## THE WATERFRONT DISTRICT REDEVELOPMENT PROJECT (Formerly Known as New Whatcom)

## FINAL ENVIRONMENTAL IMPACT STATEMENT

PORT OF BELLINGHAM

July 2010

Figure 1-2

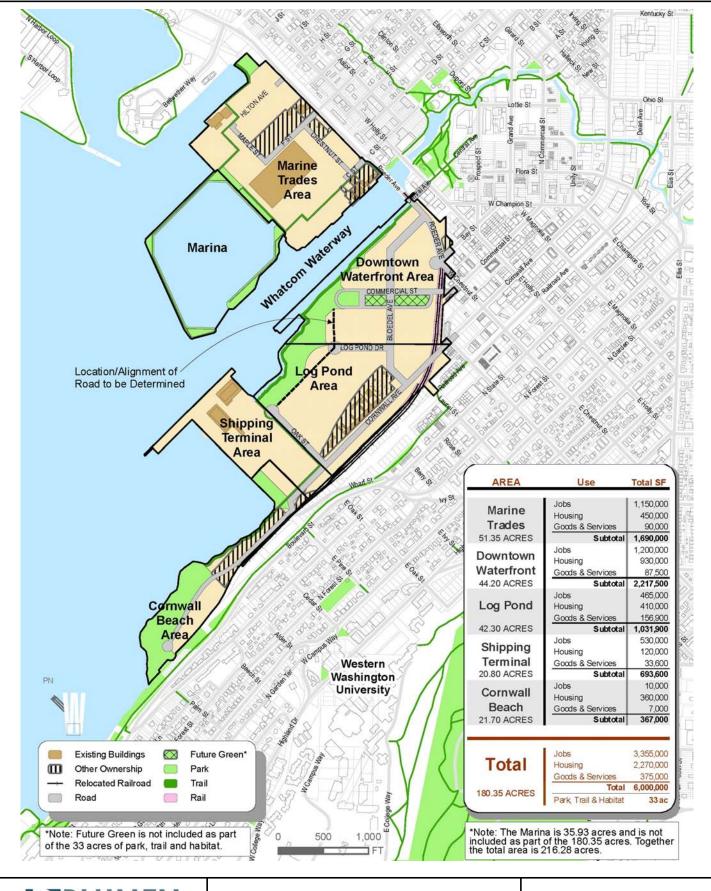
The SDEIS Preferred Alternative is based on a modified street grid for long-term redevelopment of the Waterfront District. Road improvements are discussed in Section 2.3-2 (Description of the Preferred Alternative), in Section 3.12 (Transportation), and in Appendix M. Figure 2.4 and Figure 3.12-1 show two new roadways that would pass through the existing Encogen Generating Plant. This may be a failure by the transportation planners to account for the presence of existing and important long-term generating resources. It is not possible to locate roads through the Encogen infrastructure and the concept is wholly unacceptable to PSE as currently envisioned in the SDEIS.

- 14. Comment noted.
- 15. Comment noted. The street grid configuration of the Updated Preferred Alternative, as described in Chapter 2 of the EIS Addendum, does not assume any new roadways or road right-of-ways within the existing PSE Encogen site. The Updated Preferred Alternative assumed the ongoing operation of the PSE Encogen Plant through 2026 and beyond. Please refer to **Figure 1-2** of this FEIS for a site plan illustration to proposed street grid.

Figure 1: Whatcom County annual population growth rate, 1991-2002. Data from Washington Office of Financial Management (WA OFM). Because data beyond 2002 were not available when ECONorthwest developed the model and its population projections, the figure does not show more recent values.

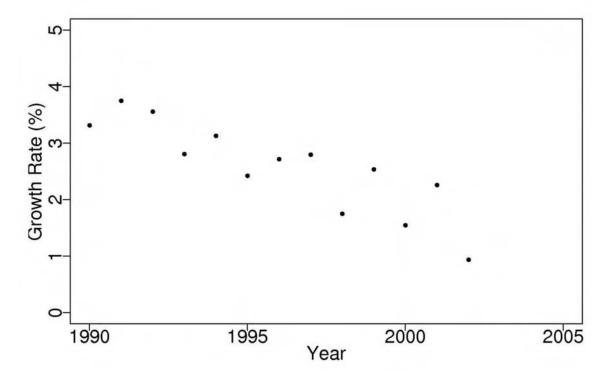
future growth rates with prior values is not appropriate when the rate itself is decreasing. As shown in below in figure 1, Whatcom County population growth rates have been declining since 1991. Declining growth rates in Whatcom County have been driven by a decline in the number of people moving here, as shown below in figure 2. ECONorthwest's model ignored these trends, leading to a substantial over-projection.

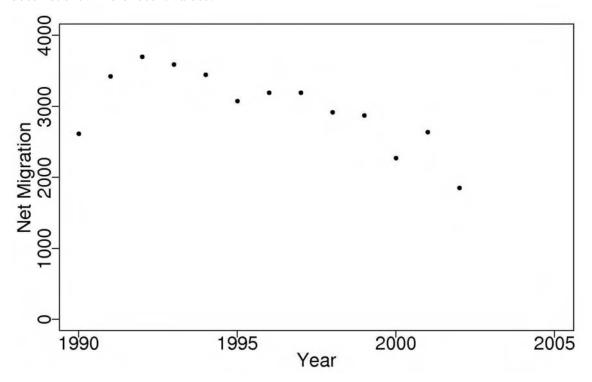
Page 3, last paragraph – page 4, first paragraph: "The implied conclusion was that Whatcom County ... will continue to attract migration. Implied in that conclusion is are [sic] assumptions, among others that (1) land will be available to accommodate new development ...."
